Applied	5/21/2019 DG
Project Number	SP2019-018	**Owner**	SARO Partners LLC	**Approved**	
Project Name	Office/Warehouse	**Applicant**	Platimum Construction	**Closed**	
Type	SITE PLAN			**Expired**	
Subtype				**Status**	
Status	Staff Review

SP2019-018 Site Plan for Office/Warehouse: Please address the following comments (M= Mandatory Comments; I = Informational Comments)

1. This is a request by Annalyse Valk of Platinum Construction on behalf of Shawn Valk of Saro Partners, LLC for the approval of a site plan for a multi-tenant office/warehouse facility on a 2.21-acre tract of land identified as Lot 6, Block A, Bodin Industrial Addition, City of Rockwall, Rockwall County, Texas, zoned Light Industrial (LI) District, addressed as 1491 T. L. Townsend Drive.

TO:	Planning and Zoning Commission
DATE:	June 11, 2019
APPLICANT:	Annalyse Valk; Platinum Construction
CASE NUMBER:	SP2019-018; *Site Plan for Office/Warehouse at 1491 T. L Townsend Dr.*

S-1

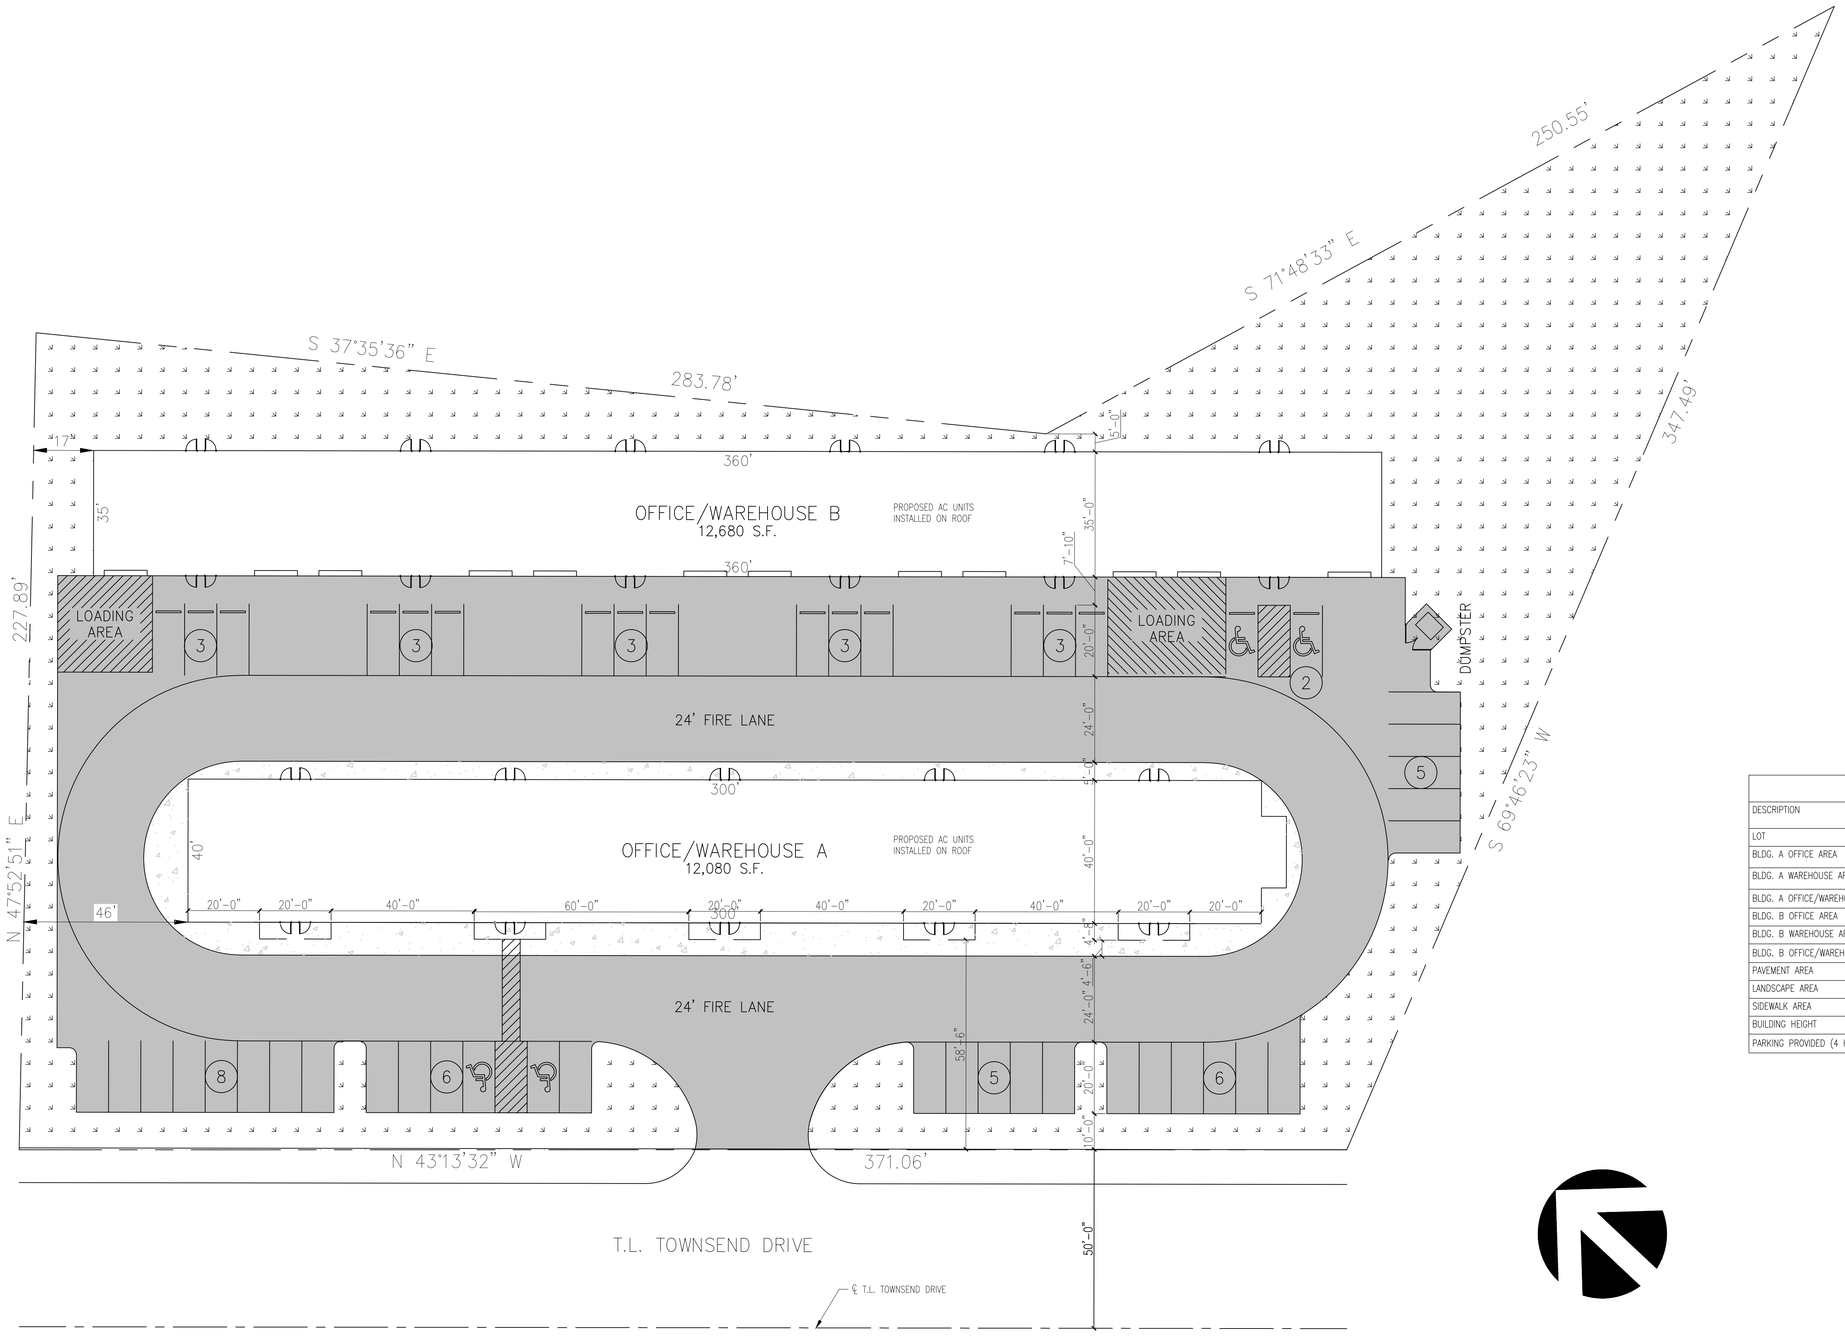
3. For reference, include the case number (SP2019-018) in the lower right hand corner of all pages on future submittals.
4. Sheet S-1—Please add the following to the site data table: pervious vs. impervious area and %, req. parking, office SF, warehouse SF.

5. Sheet S-1—Please add engineering information (e.g. all easements, radii, topo, etc) graphic scale, vicinity map.
6. Sheet S-1—Please label property line.

7. Sheet S-1---Please show full extend of T.L. Townsend and label centerline.
8. Sheet S-1—What is the hatch pattern covering the site? Please remove
9. Sheet S-1—Please show fireline and one shade of grey and non-firelane/sidewalks as a lighter shade.

10. Sheet S-1—Please show all sidewalks
11. Sheet S-1—Please provide paving material and depth.
12. Sheet S-1--what is the hatch pattern closest to the buildings?

13. Sheet S-1—Please show all building setbacks and landscape buffers.
14. Sheet S-1—Please show adjacent properties and provide property information.
15. Sheet S-1—Please note that as drawn, this will need variances to horizontal articulation.

16. Sheet S-1—Please note that Building B appears to be too close to the property line. Please provide dimension from building to all property lines.
17. Sheet S-1—Please note that parking spaces are 9x20. Please dimension a typical parking space.

18. Sheet S-1—Please label the space between each group of parking spaces.
19. Sheet S-1—What are the “L” shape lines next to each of the doors on Building A?

20. Sheet S-1—Please note that no parking space shall be more than 80-feet from a large tree.
21. Sheet S-1—Please provide owner/engineer/developer information on site plan.

22. Sheet S-1—Please note that the dumpster enclosure shall be 6-feet in height and constructed of materials matching main structure with opaque self-latching gate. Please add note to plans.

23. Sheet S-1—Please note that all plans need to be prepared by a registered architect, engineer, or landscape architect. There does not appear to be any engineer/architect seal on the site plan.

sheet
L-1

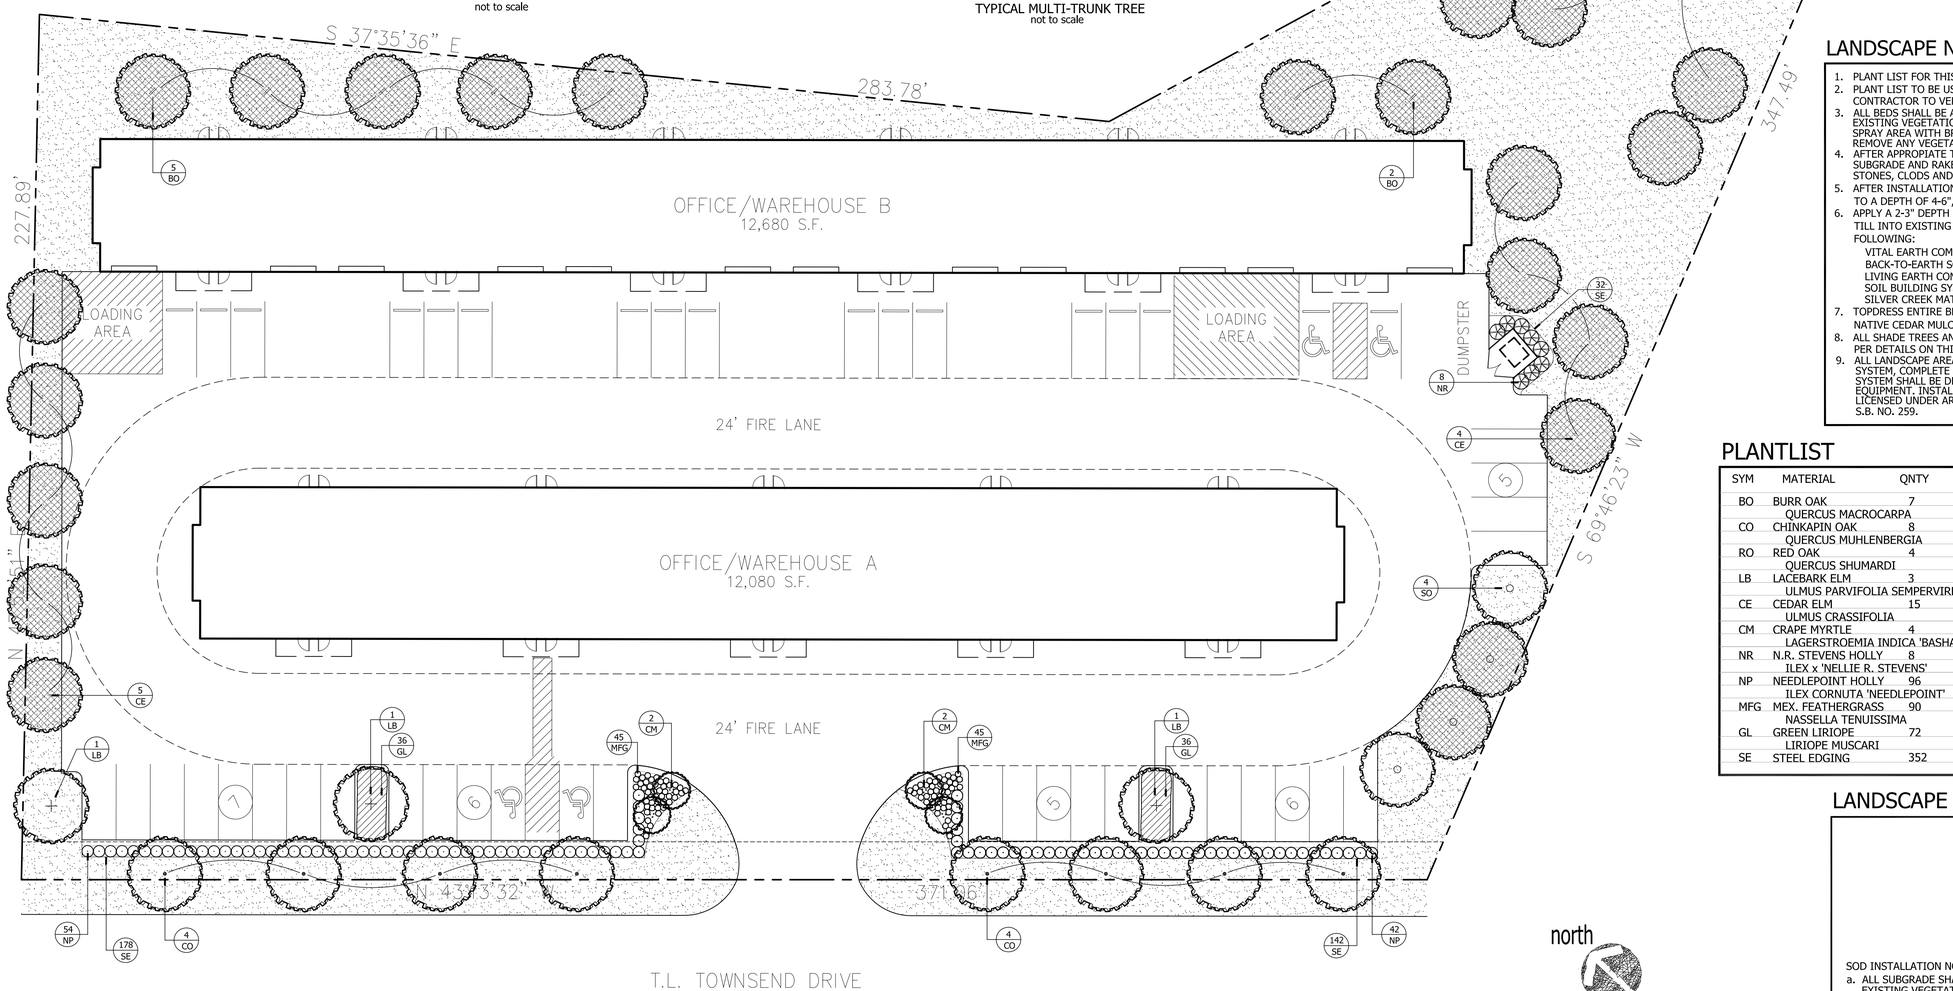
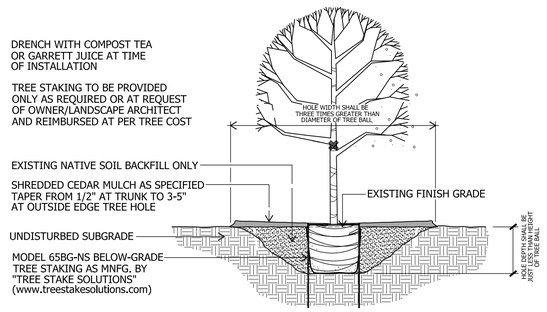
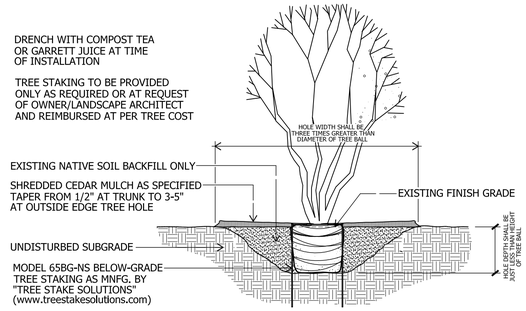
24. Sheet L-1—Please note that the min caliper-inch off trees is 4 caliper inches.
25. Sheet L-1—Please provide vicinity map
26. Sheet L-1—For clarity, please do not show stippling under the tree symbols.

27. Sheet L-1—Please show the full extent of TL. Townsend and show and label centerline.
28. Sheet L-1—Please note that no parking space shall be more than 80-feet from a large tree.

29. Sheet L-1—For clarity, please see note above regarding pavement/firelane shading.
30. Sheet L-1—Please dimension a typical parking space.
31. Sheet L-1—Please label the large space between the groups of parking spaces at Building B.

32. Sheet L-1—Please show all sidewalks
33. Sheet L-1—Please note that the building footprints are not consistent with the site plan.
34. Sheet L-1—Please provide site data table

35. Sheet L-1—Please show and label adjacent properties.
36. Sheet L-1—Please dimension drive approach.

sheet
T-1

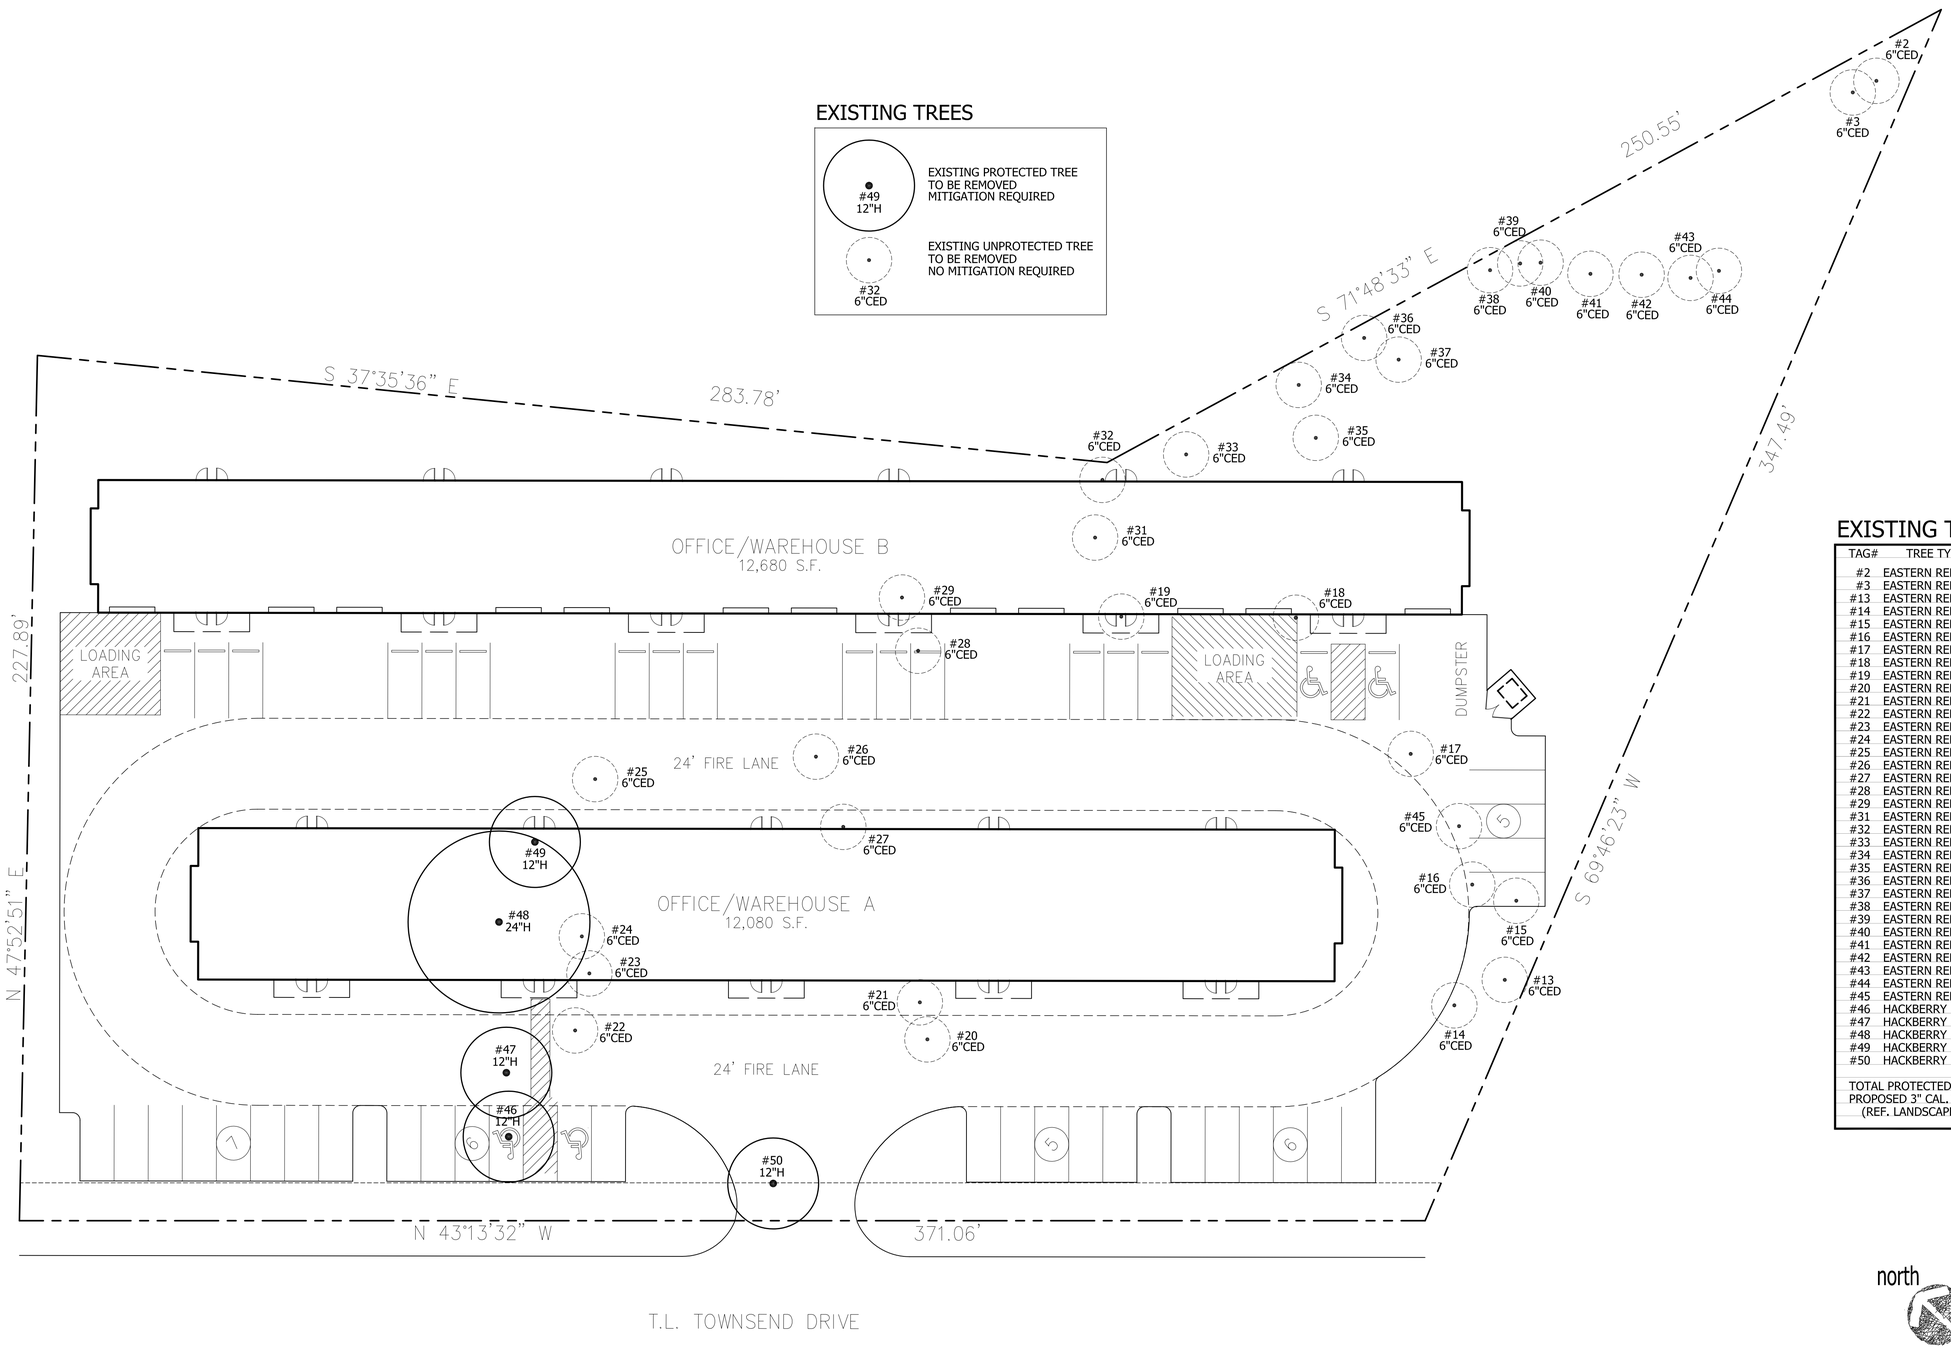
37. Sheet T-1—Please see notes from L-1
38. Sheet E1.1—Please remove the hatch from the site.
39. Sheet E1.1—Please darken and label property line
40. Sheet E1.1—Please site data table

PHOTOMETRIC SITE PLAN

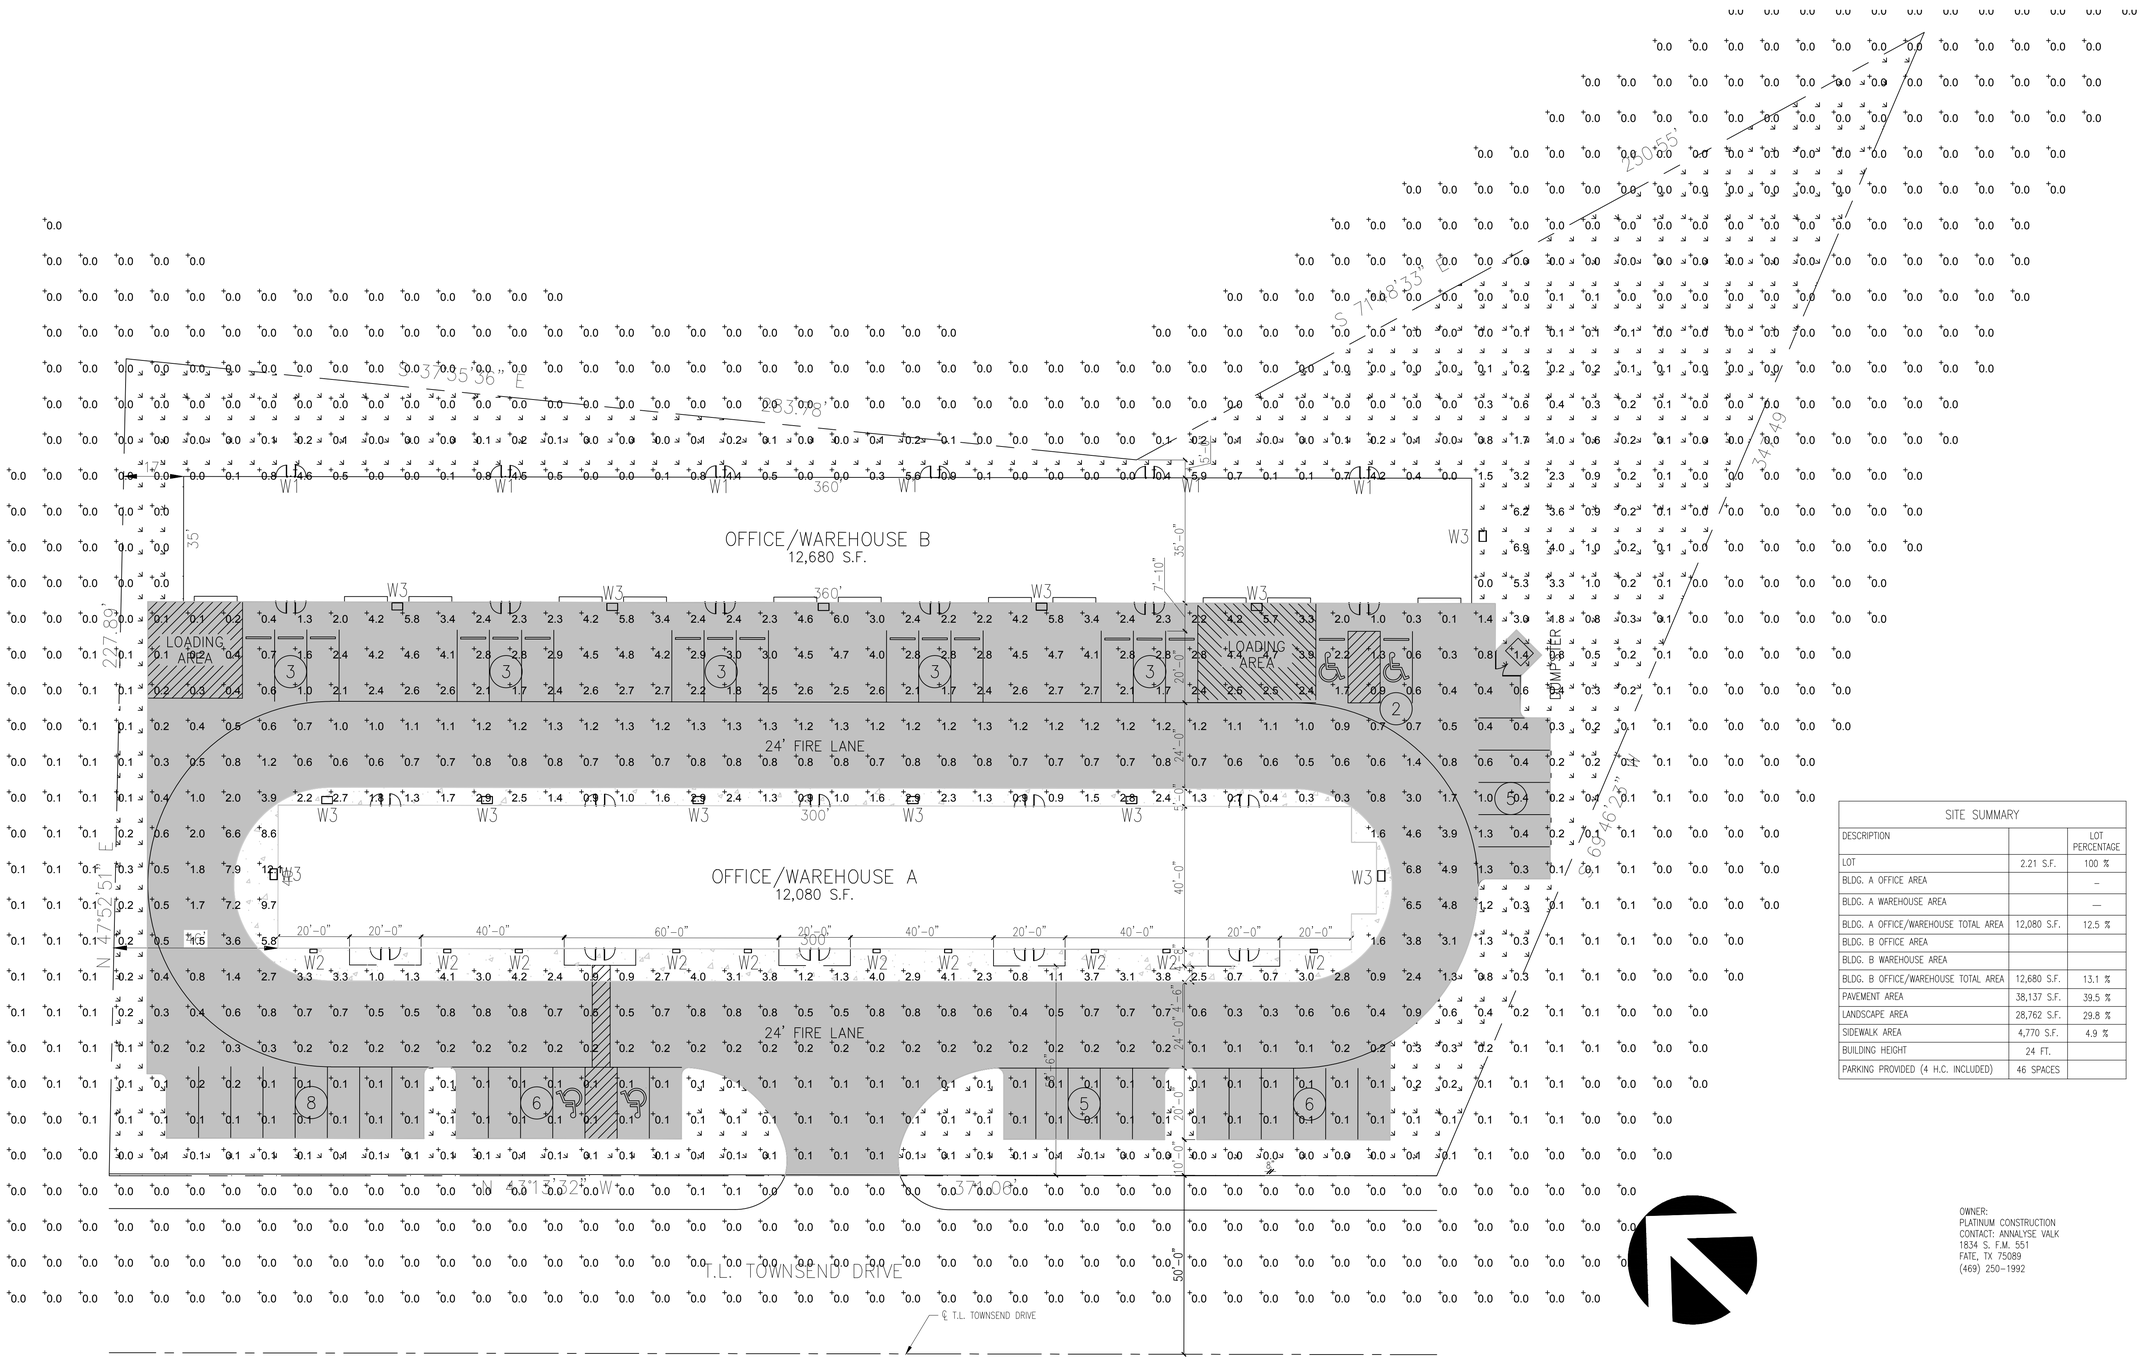
41. Sheet E1.1—Please provide vicinity map
42. Sheet E1.1—Please show and label adjacent properties.43. Sheet E1.1—Please provide graphic scale
44. Sheet E1.2—Please note that all fixtures must be fully shielded and pointed downward. The third fixture shown on this page is not fully shielded.

45. Sheet E1.1—Please note that the building footprints are not consistent with site plan and landscape plan.
46. Sheet A-2—Please add site data table
47. Sheet A-2—Please note that each building needs its own set of elevations.
